Addendum No. 1
August 23, 2024

Project: KOA – Rapid City Office
Rapid City, South Dakota
#3017

Architect: Architecture Incorporated

1 LOWER LEVEL HVAC PLAN
8.31 1/8" = 1'-0"

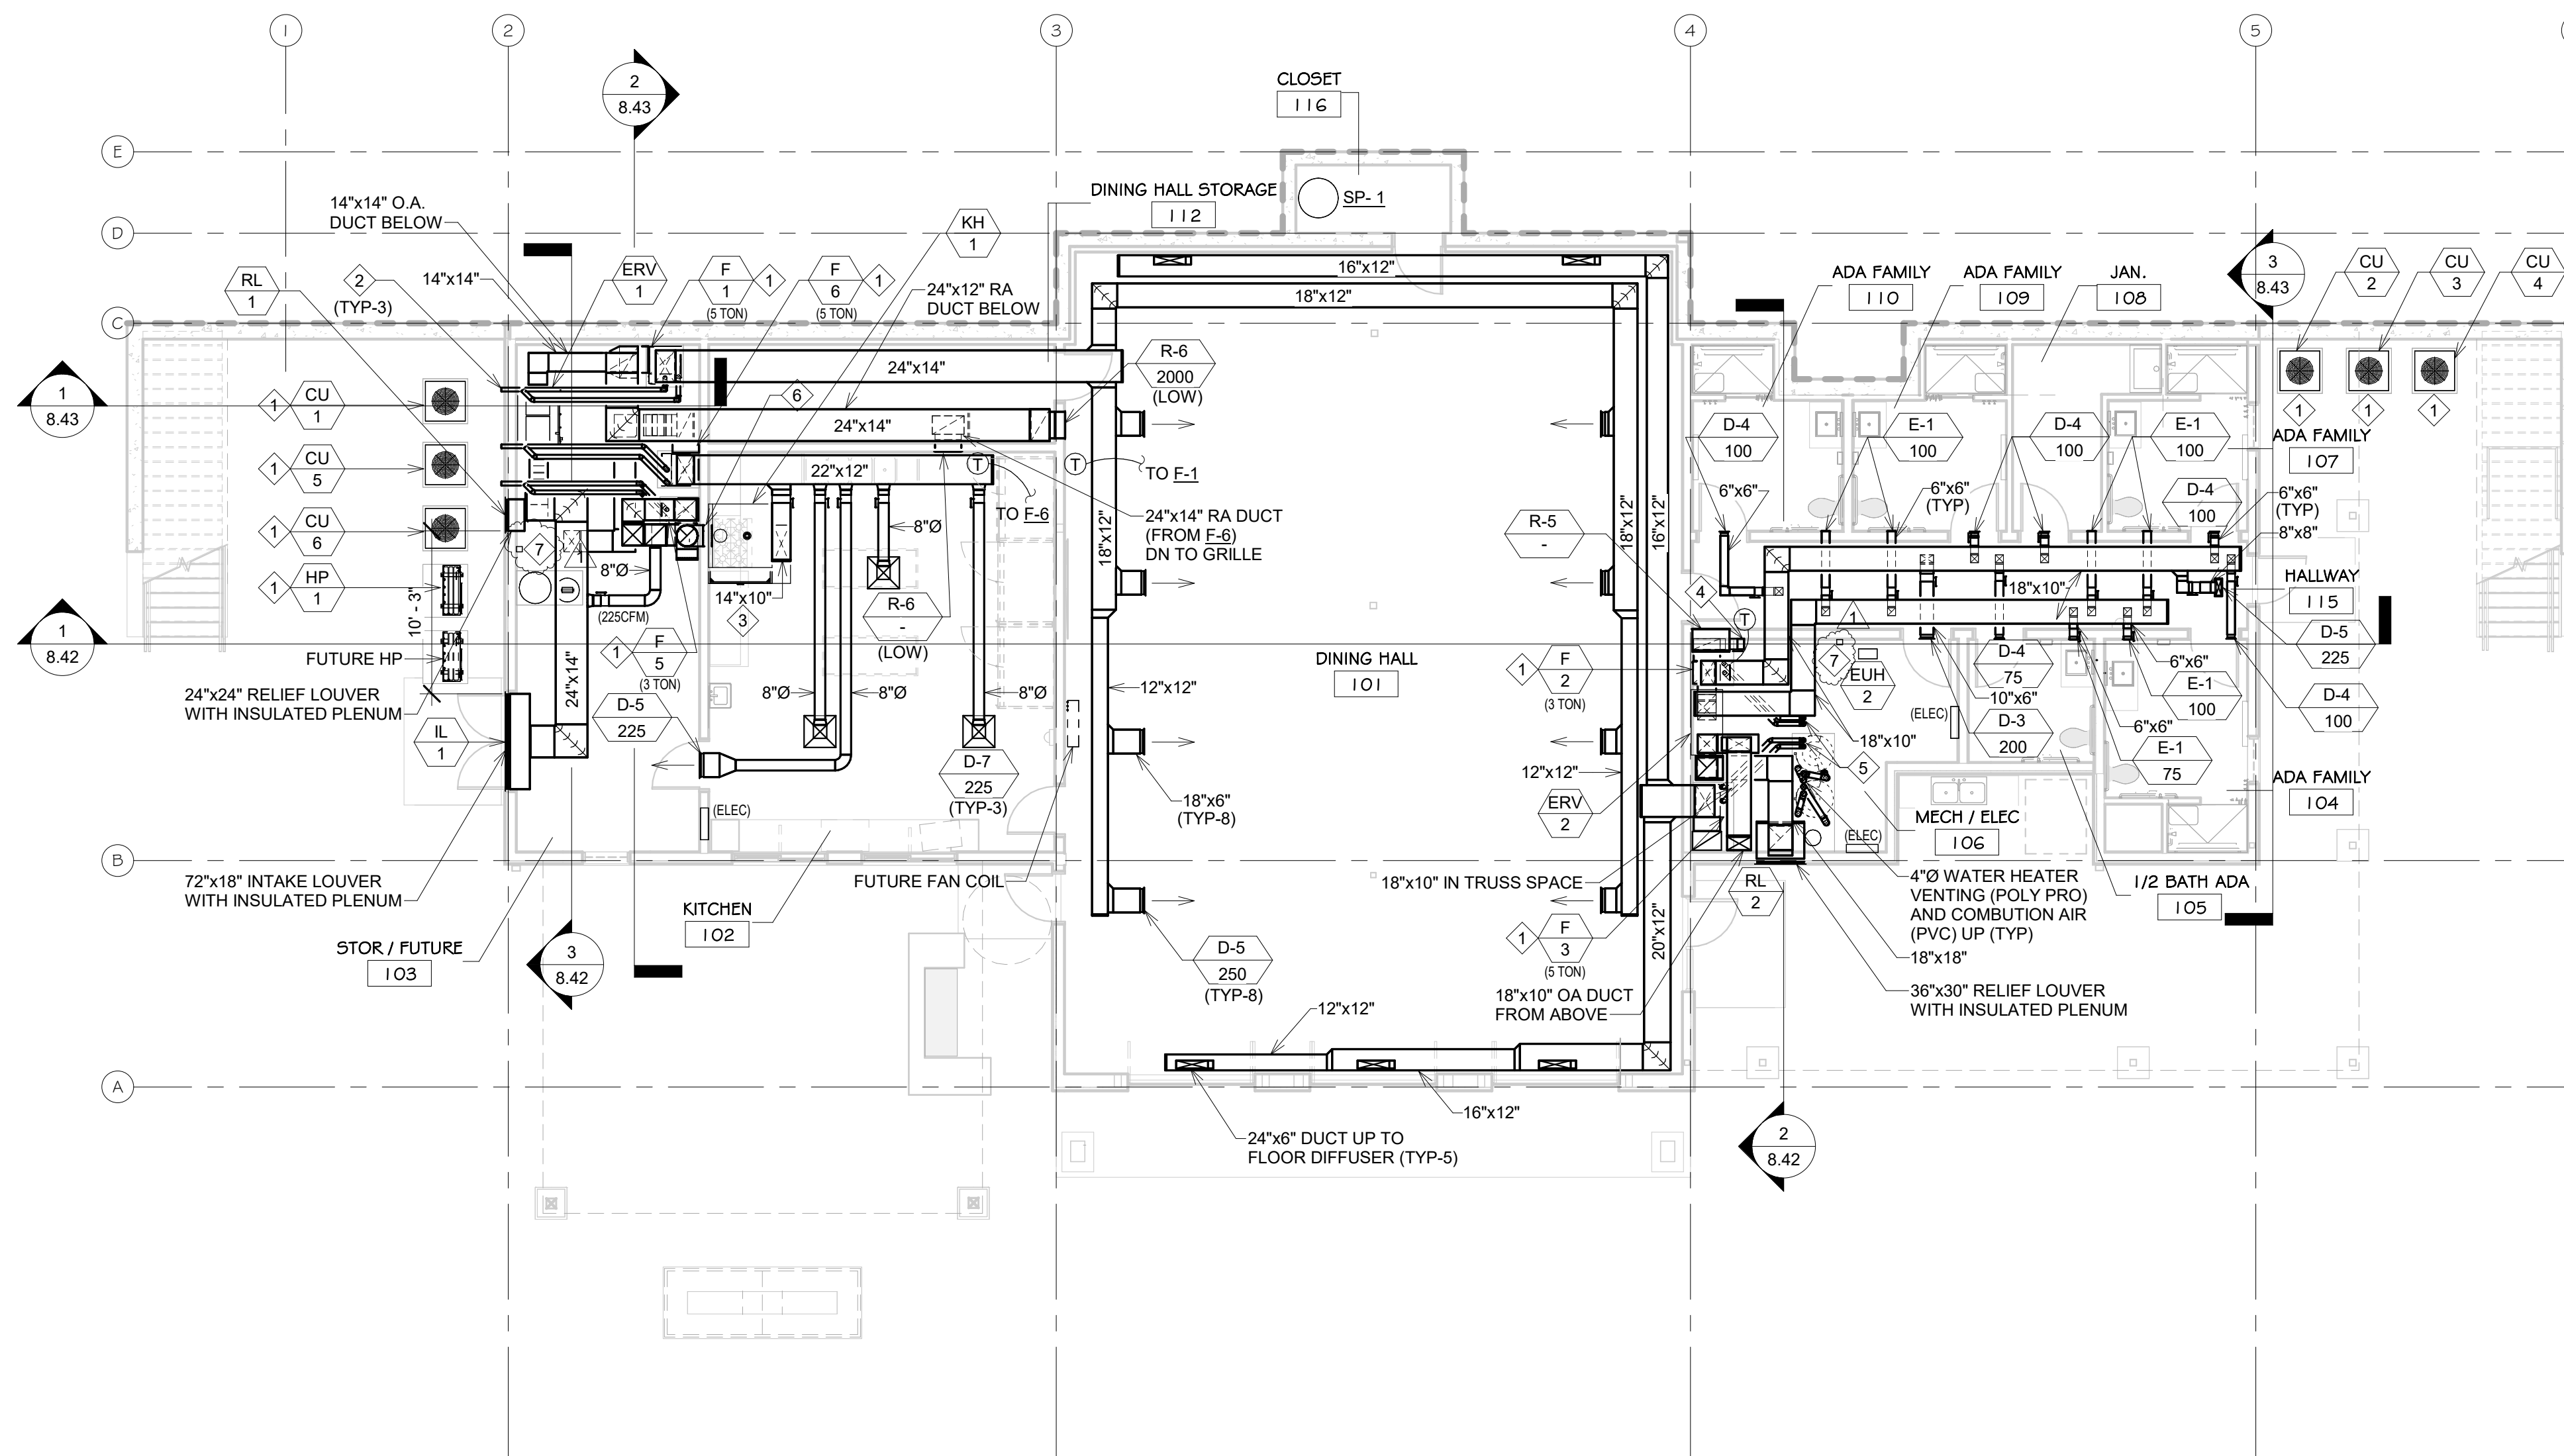
- 1) Specifications Revisions:
 - a) None
- 2) Drawing Revisions:
 - a) Sheet 8.31 Lower Level HVAC Plan:
 - i) Refer to plan for location of ERV timer controls.
 - b) Sheet 8.32 Upper Level HVAC Plan:
 - i) Refer to plan for location of ERV timer controls.
- 3) Prior Approvals.
 - a) Contractors and Vendors shall note that space is limited in mechanical locations and it is the responsibility of the Contractor to verify whether equipment substitutions will fit into the allotted space.
 - b) See Division 01 Specifications for Substitution Request forms. These forms are required to be completed for any equipment substitutions prior to or after the bid.
 - c) Subject to project requirements, the following manufacturers are allowed for bidding purposes:
